INDIAN POINT NUCLEAR GENERATING UNIT NO. 2

AMENDMENT TO FACILITY OPERATING LICENSE

Amendment No. 69
License No. DPR-26

ATTACHMENT TO LICENSE AMENDMENT NO. 69

Figure 3.10-2 a

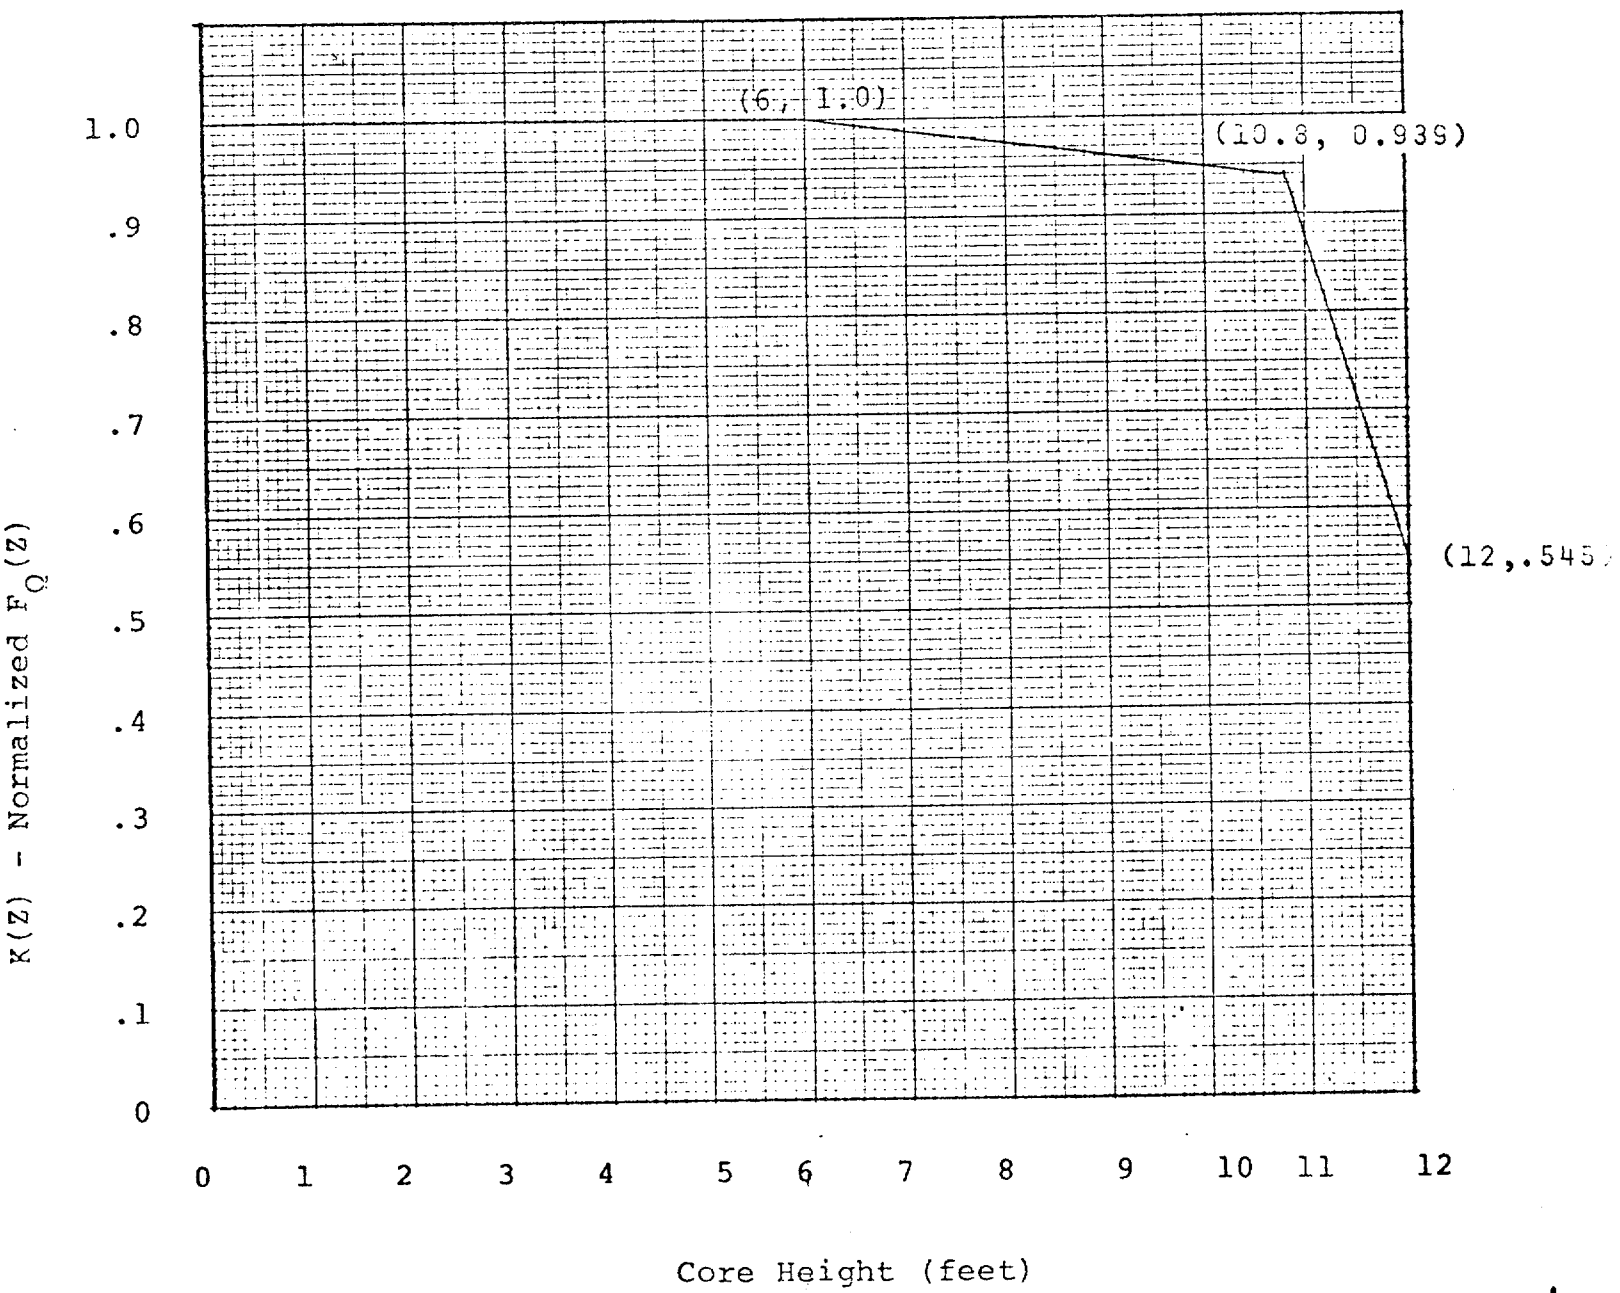
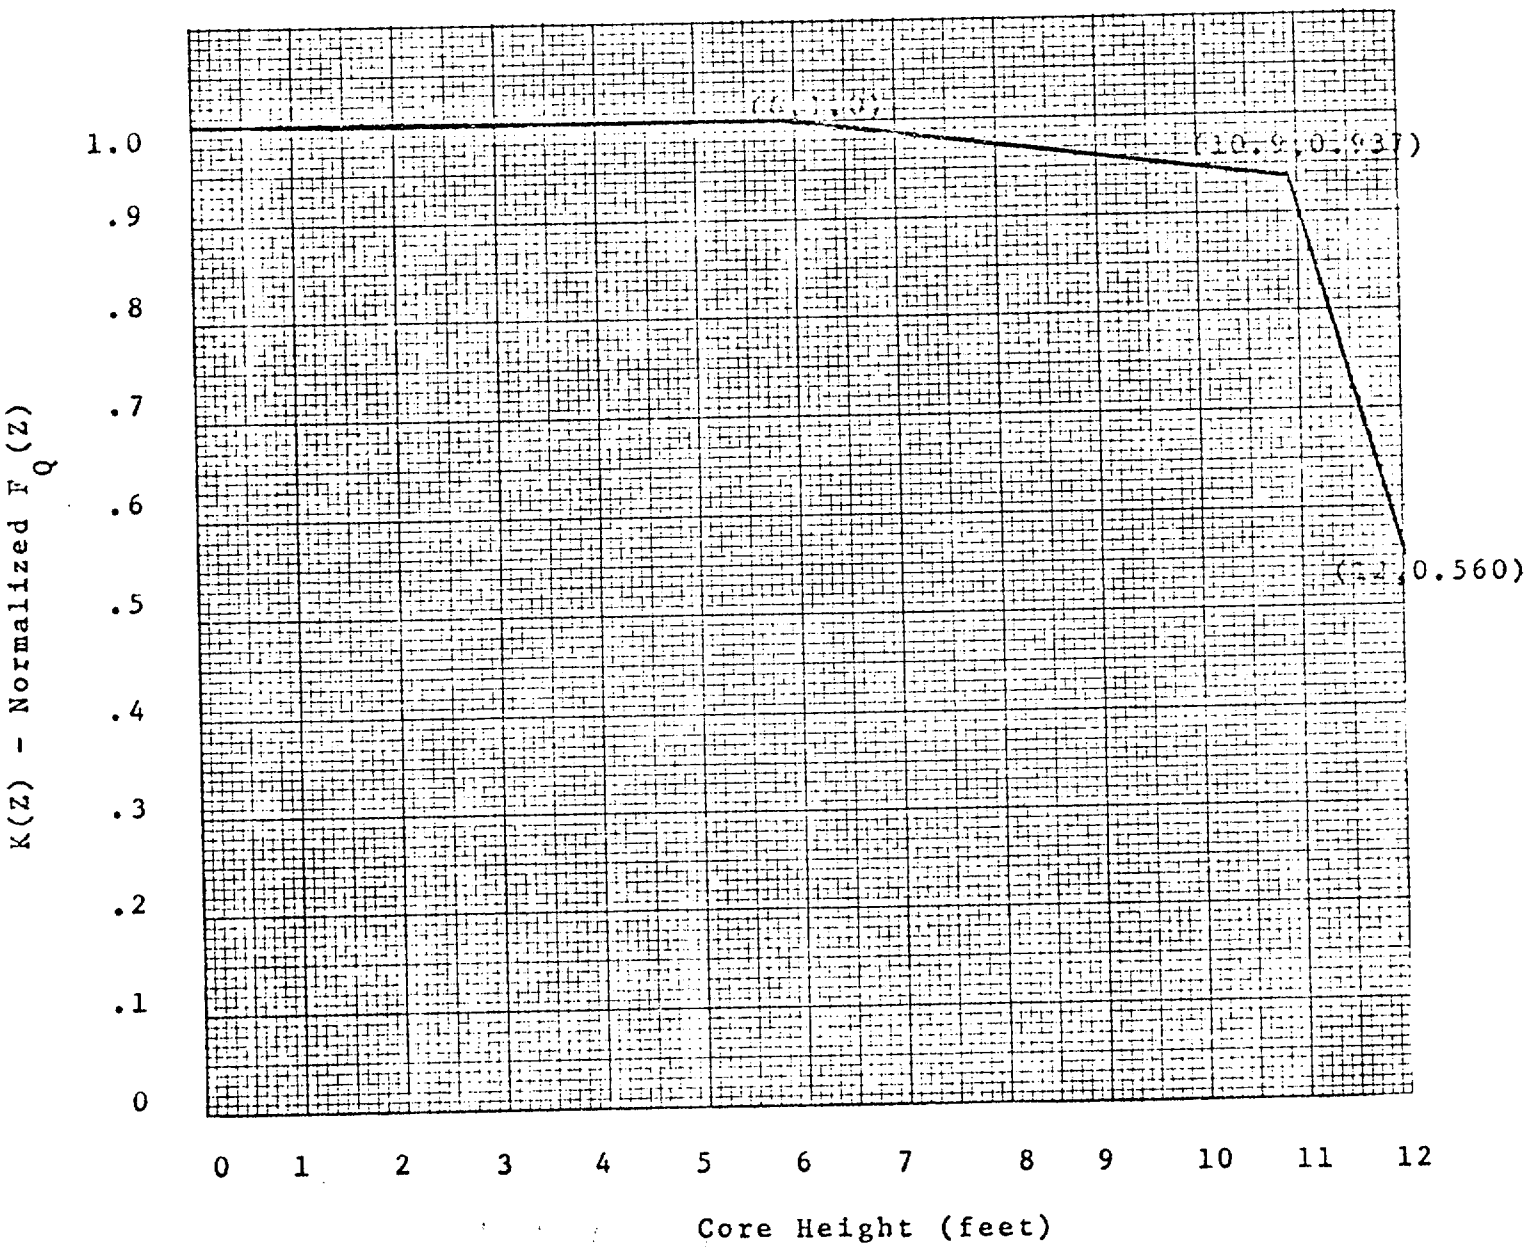
where P is the fraction of full power at which the core is operating; K(Z) is the fraction given in Figure 3.10-2a (for $\leq$ 6% tube plugging) or Figure 3.10-2b (for $>$ 6% but $\leq$ 12% tube plugging); and Z is the core height location of F_Q.

The upper bound envelope of the total peaking factor (F_Q) of specification 3.10.2.1 times the normalized peaking factor axial dependence of Figures 3.10-2a and b has been determined from extensive analyses considering all operating maneuvers consistent with the technical specifications on power distribution control as given in Section 3.10. The results of the loss of coolant accident analyses based on the specified F_Q times the normalized envelope of Figures 3.10-2a and b indicate a peak clad temperature of less than 2200°F for the double-ended cold leg guillotine break with C_D=0.6, the worst case break.(1) (2)

(c) For $>$ 6% but $\leq$ 12% steam generator tube plugging:

$F_Q(Z) \leq (2.25/P) \times K(Z)$ for $P > .5$

$F_Q(Z) \leq (4.50) \times K(Z)$ for $P \leq .5$
